737

Service Bulletin

Number: 737-28A1206
Original Issue: January 11, 2006
Revision 2: May 21, 2009
ATA System: 2822 3152

SUBJECT: FUEL - Distribution - Center Fuel Tank Boost Pump Auto Shutoff and Master Caution Logic Change

FIGURE 11: J20 JUNCTION BOX - REMOVAL AND SALVAGE
(SHEET 1 OF 4)

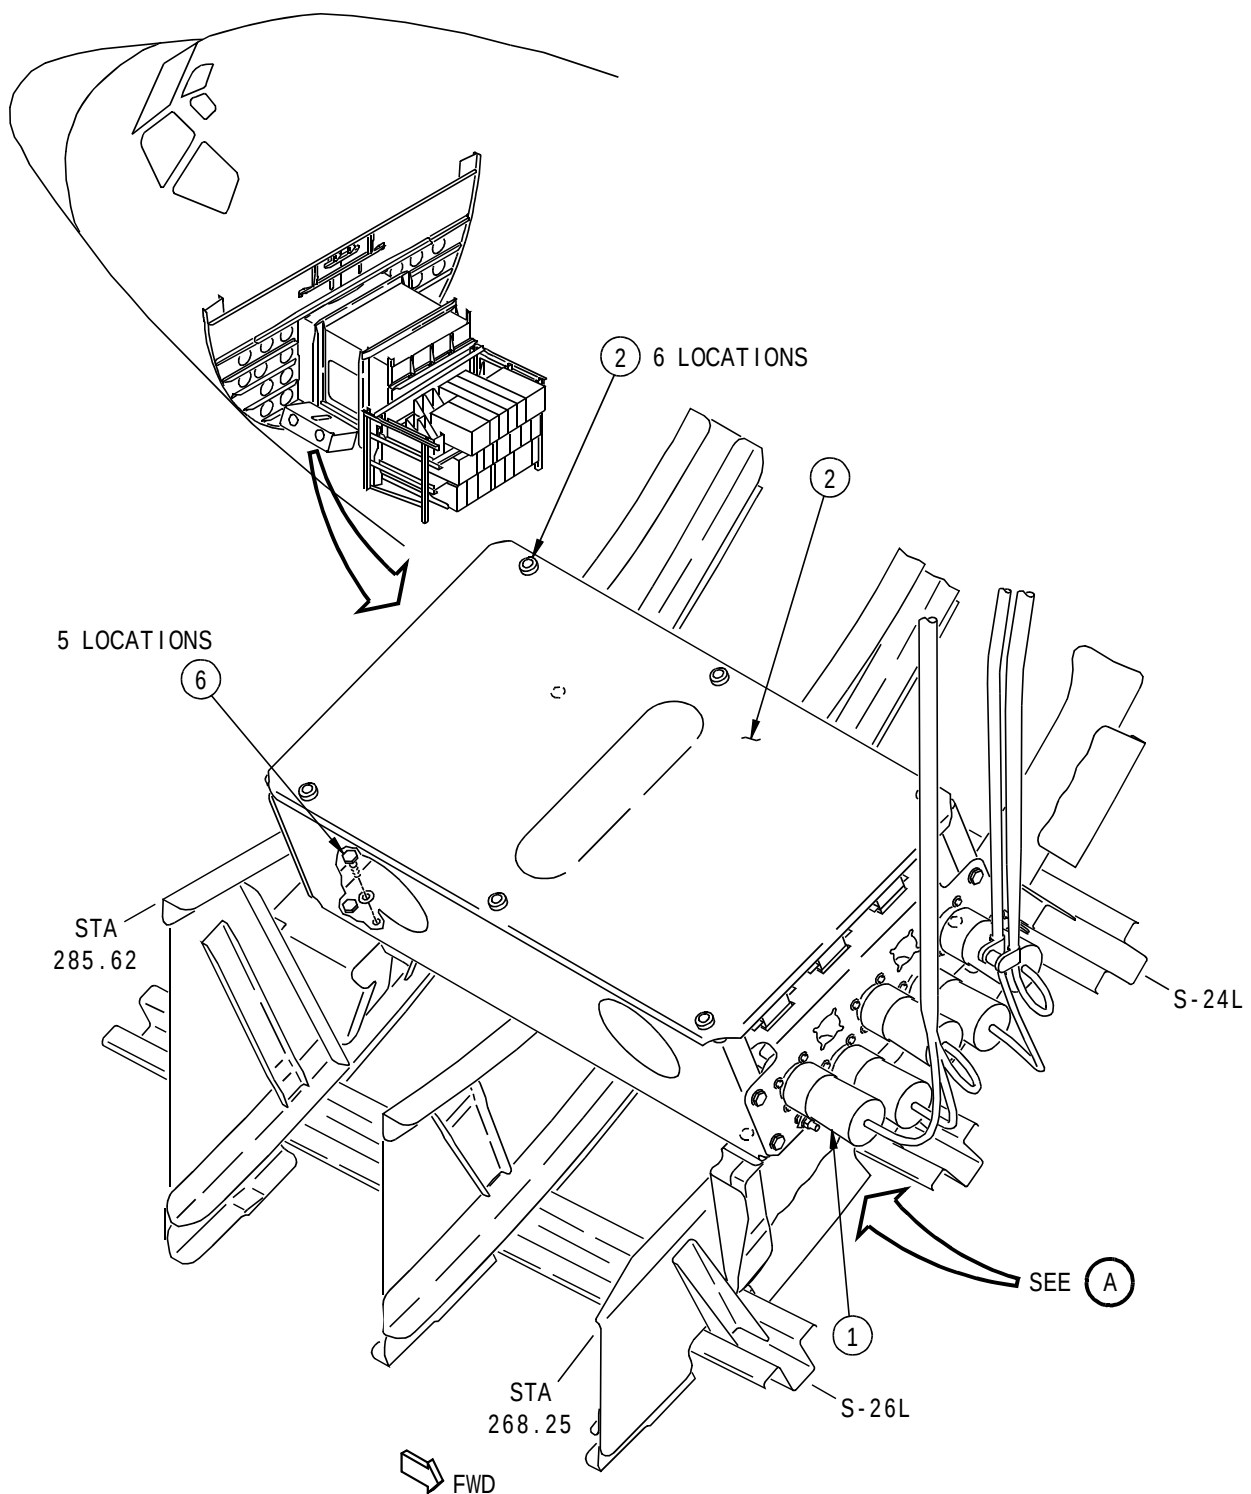
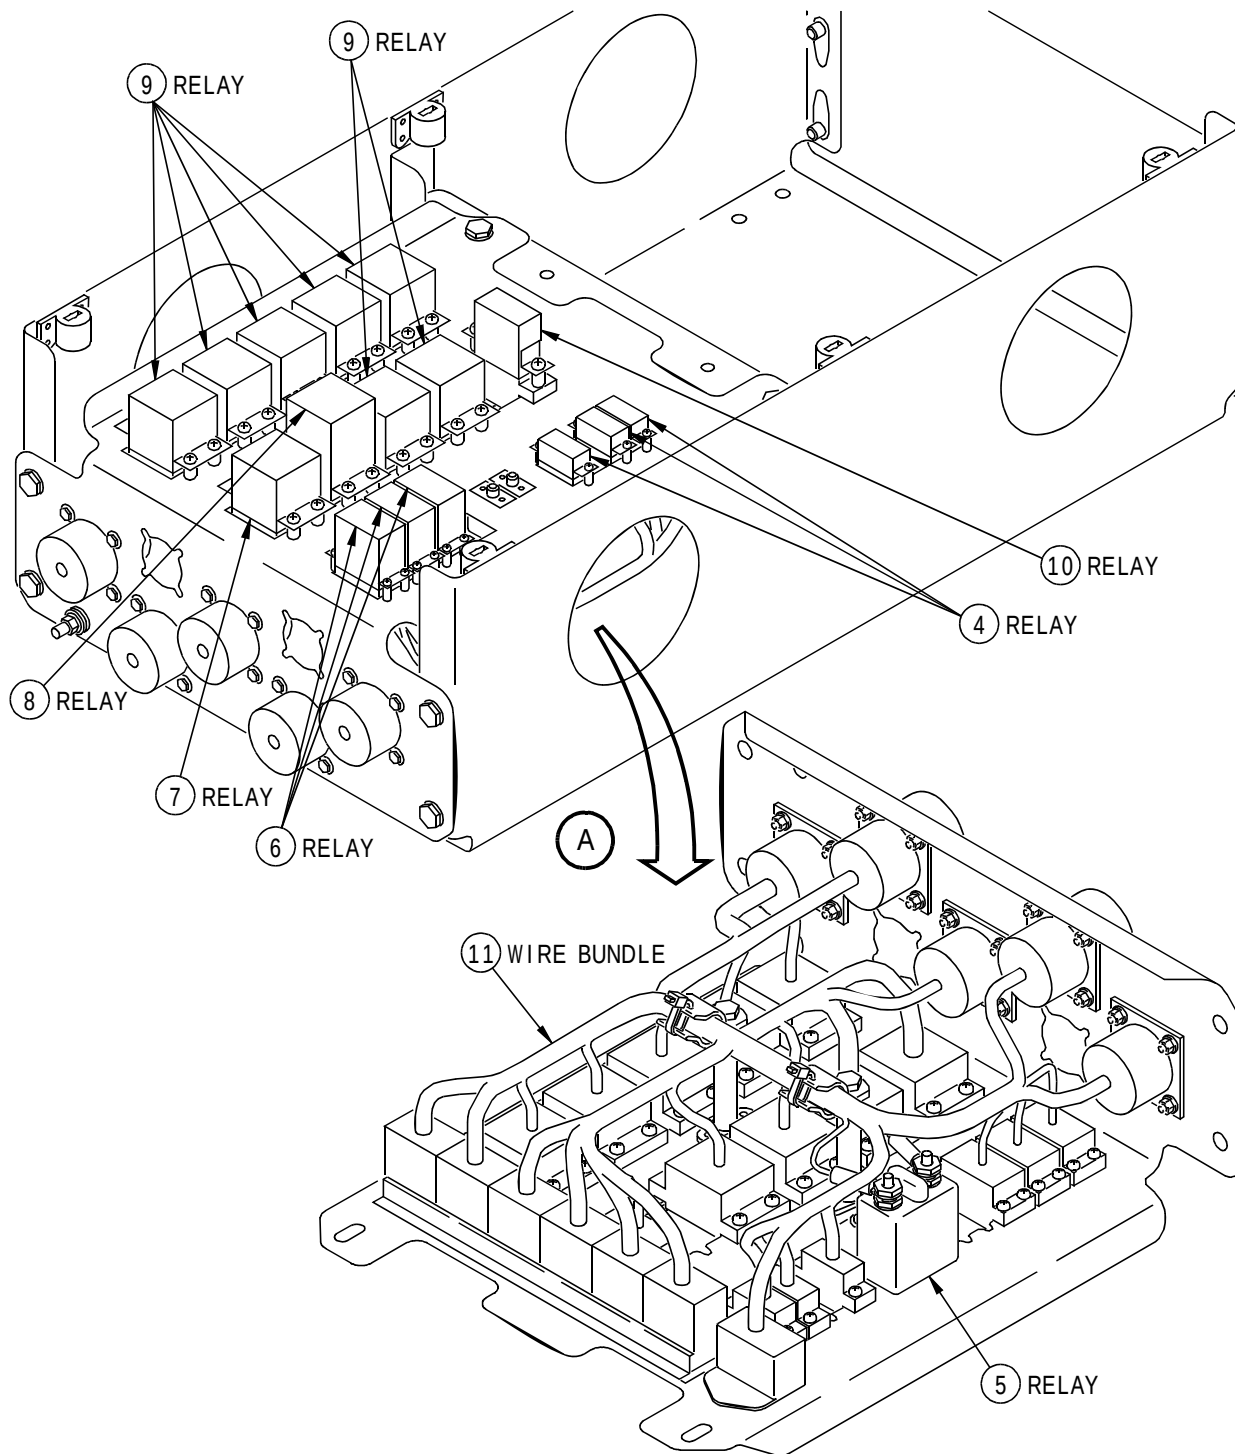
Changes are made to Figure 11 to add a new Step 1 to disconnect all the connectors from the J20 junction box and all the remaining Steps are re-sequenced. A new step is added to clarify the J20 junction box is discarded after the J20 junction box plate B is removed. Sheet 3 is added to Figure 11 to clarify the installation of the electrical jumper from the J20 junction box to the structure. Note (b) is added to clarify the J20 junction box plate B is discarded after all the parts are removed.

FIGURE 14: J20 JUNCTION BOX, PLATE A AND PLATE B - INSTALLATION

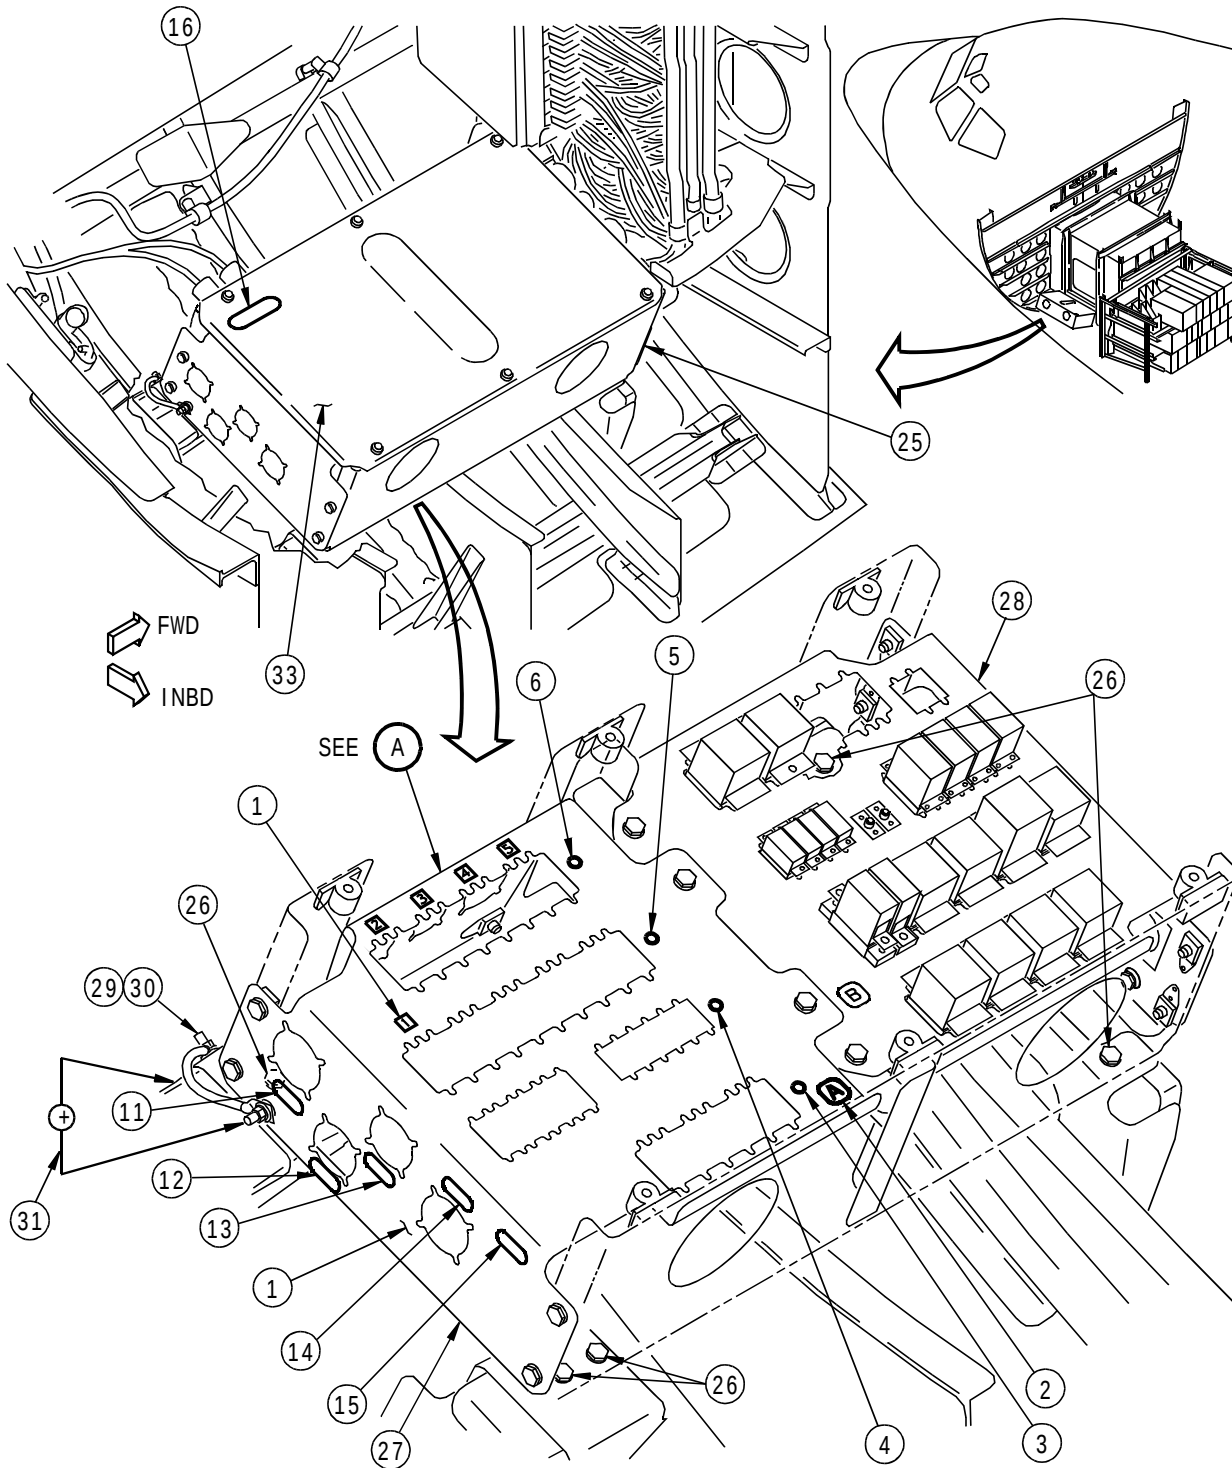
Changes are made to Figure 14 to re-sequence the installation of the J20 junction box in the airplane and the installation of the J20 junction box plate A and plate B in the J20 junction box.

FIGURE 15: J20 JUNCTION BOX - REMOVAL AND SALVAGE

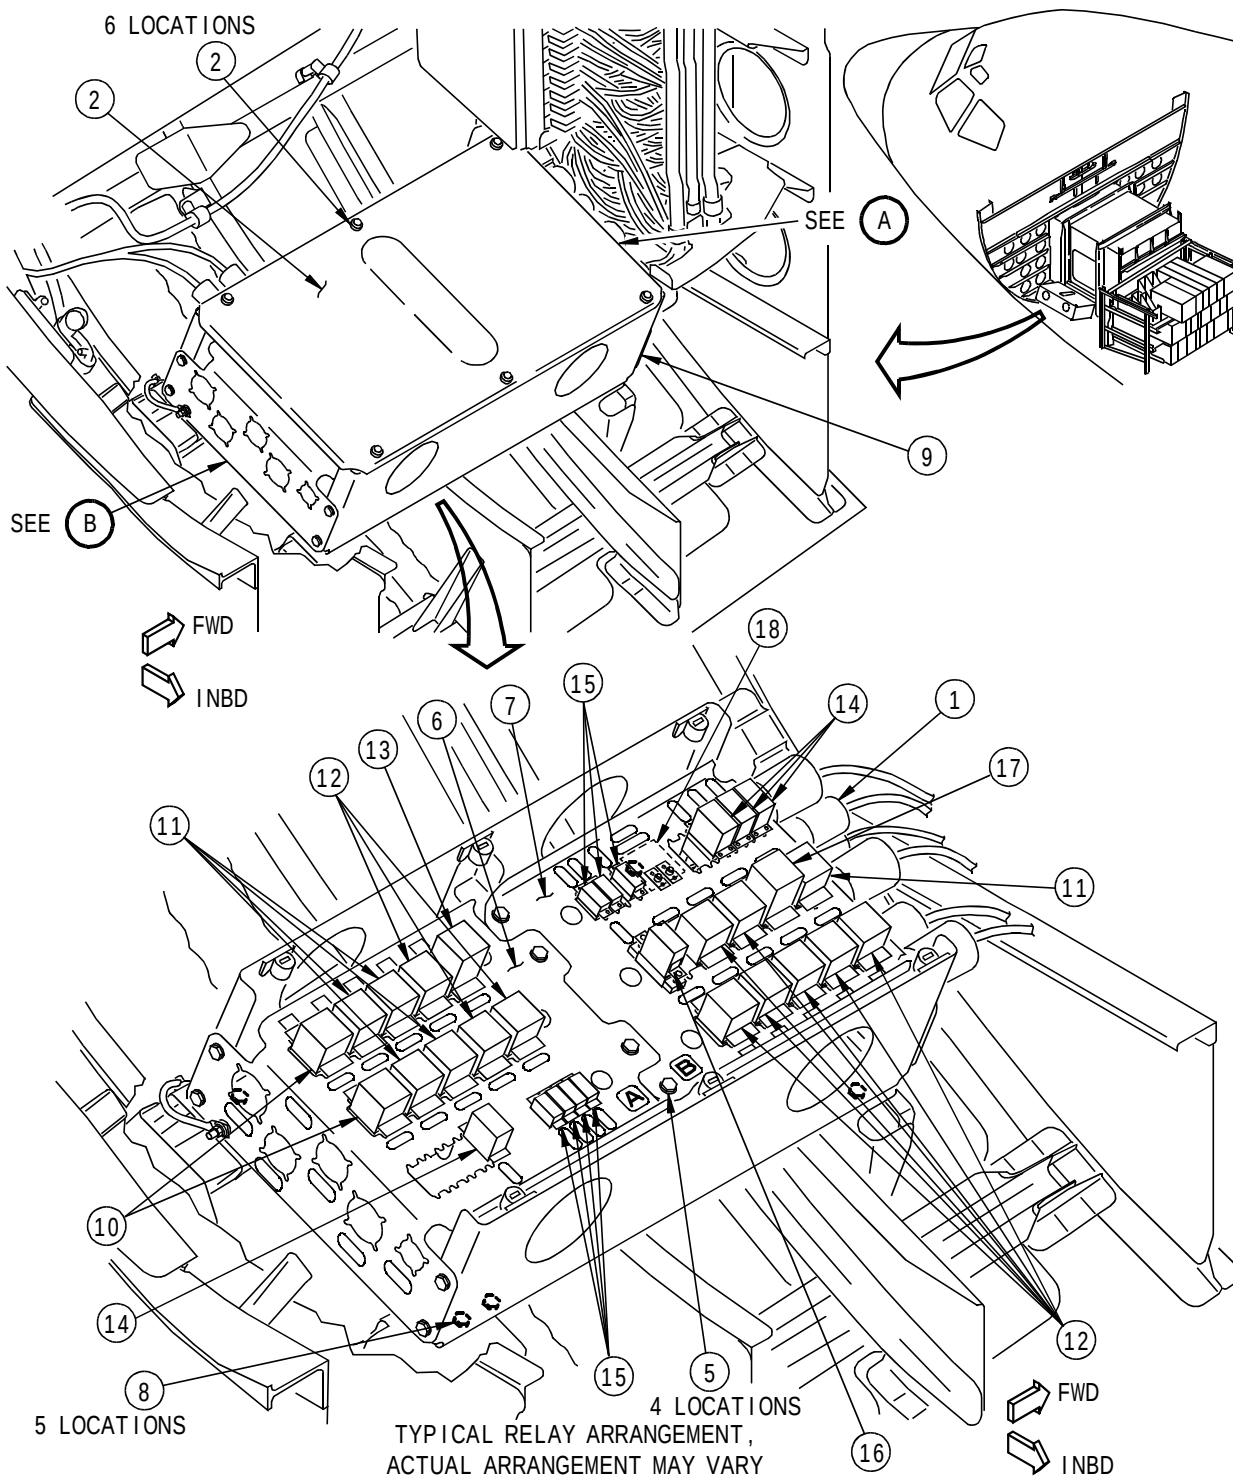
Changes are made to Figure 15 to add a new Sheet 2 to show the removal of the electrical jumper from the J20 junction box plate B, and the removal of the electrical jumper from the structure. Changes are made to the step table to add a new Step 1 to disconnect all the connectors from the J20 junction box and all the remaining Steps are re-sequenced. Note (b) is added to clarify the J20 junction box plate A and plate B are discarded after all the parts are removed.

FIGURE 21: J20 JUNCTION BOX - REMOVAL AND SALVAGE

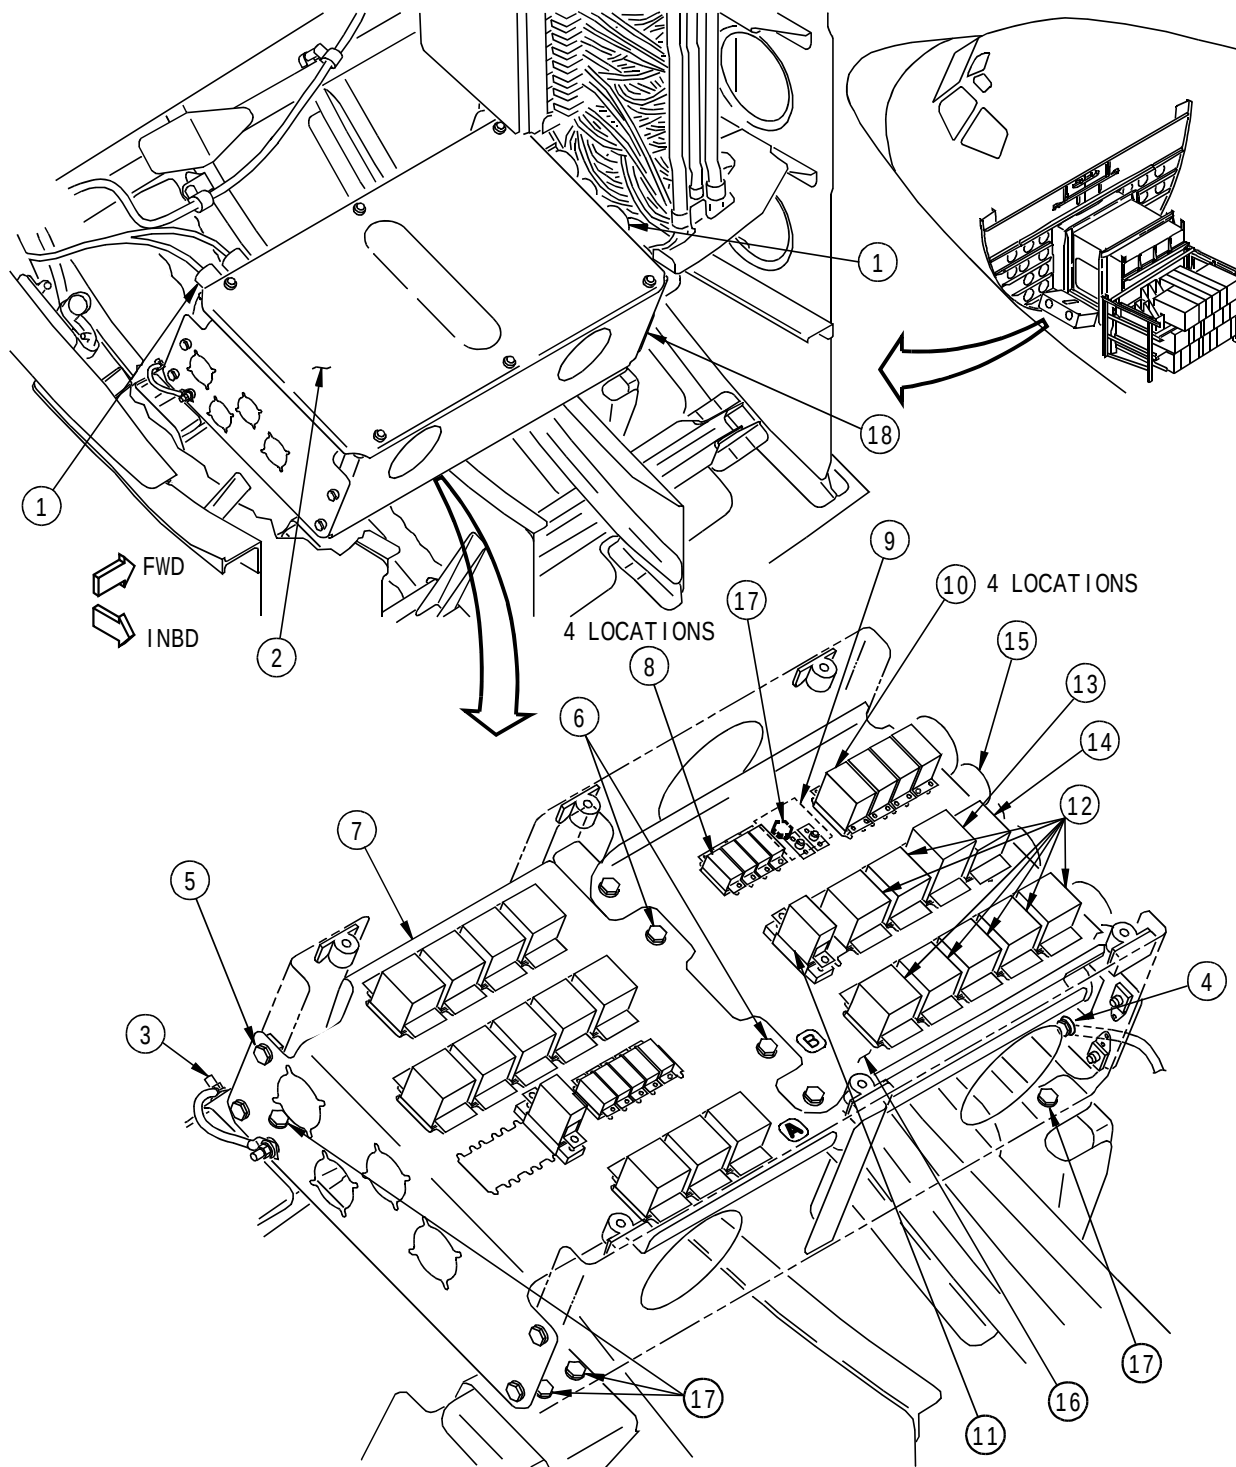
Changes are made to Figure 21 to add a new Step 1 to disconnect all the connectors from the J20 junction box and all the remaining Steps are re-sequenced. Changes are also made to remove the J20 junction box plate B.

FIGURE 32: P6-3 PANEL CIRCUIT BREAKER INSTALLATION

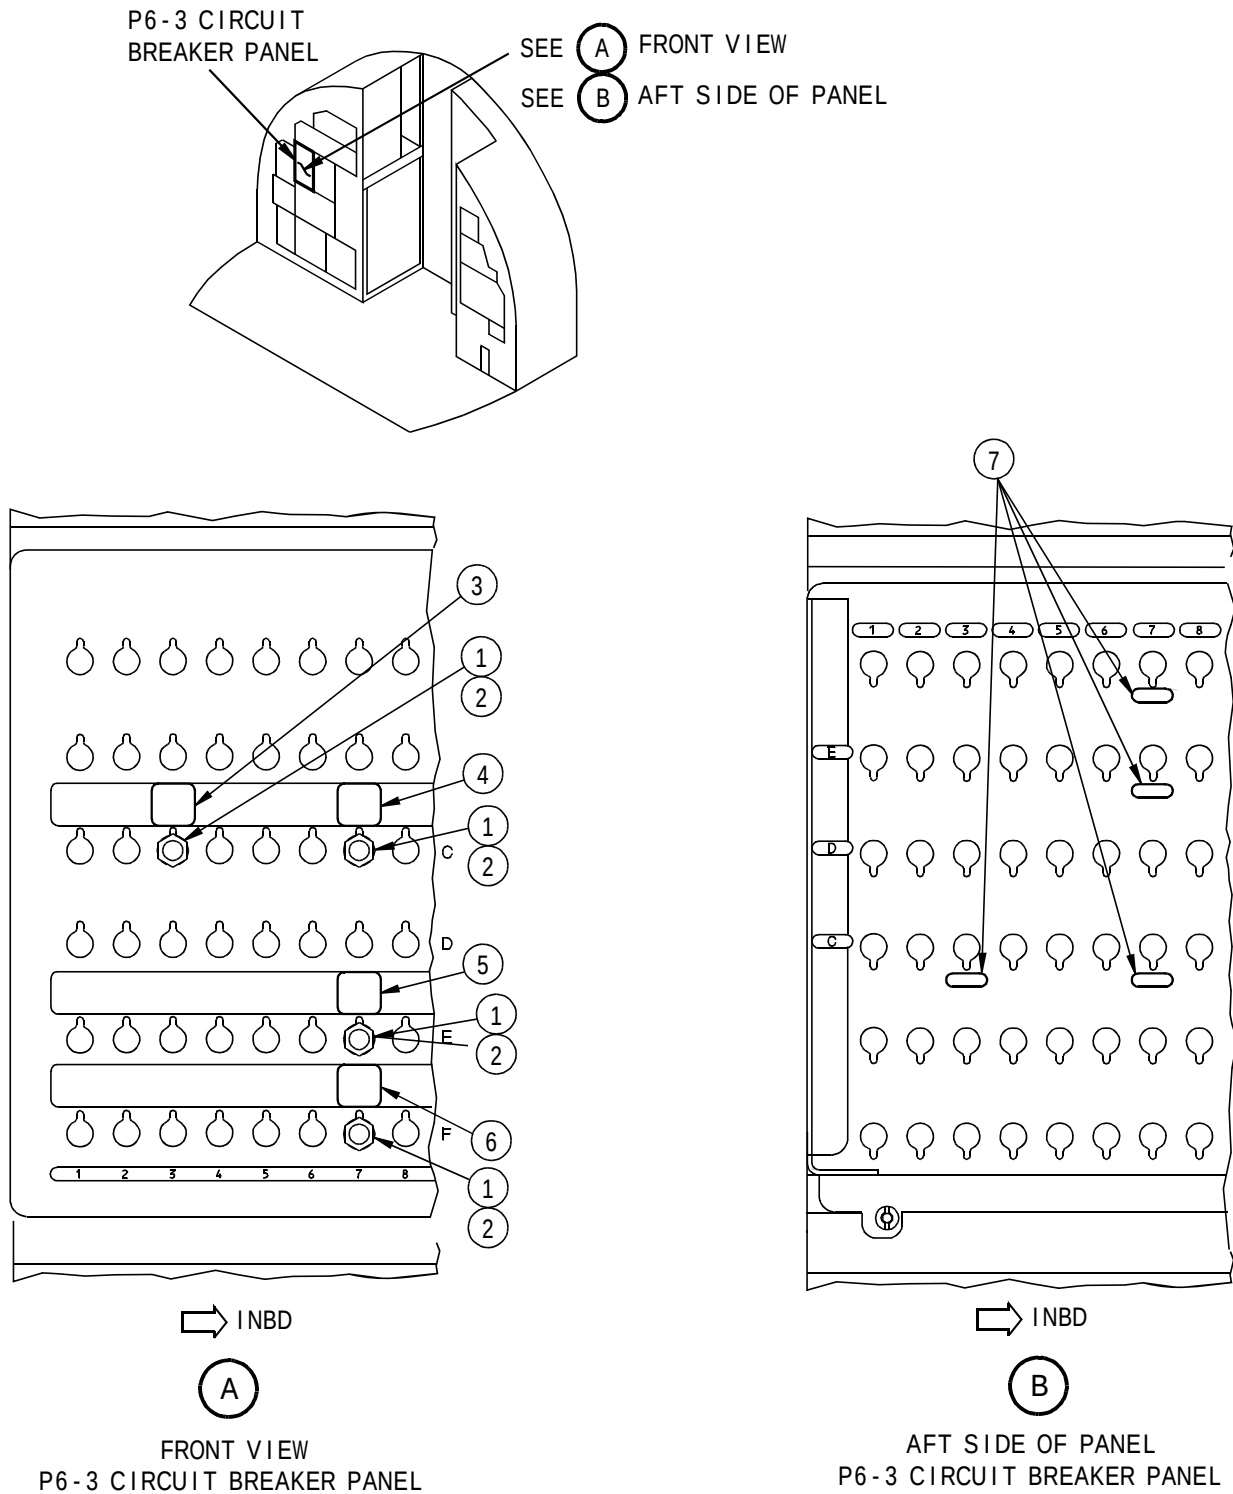
Changes are made to Figure 32 Step 5 to change Marker part number from BAC27DCC3399 to BAC27DCC3400, and to Step 6 to change Marker part number from BAC27DCC3400 to BAC27DCC3399.
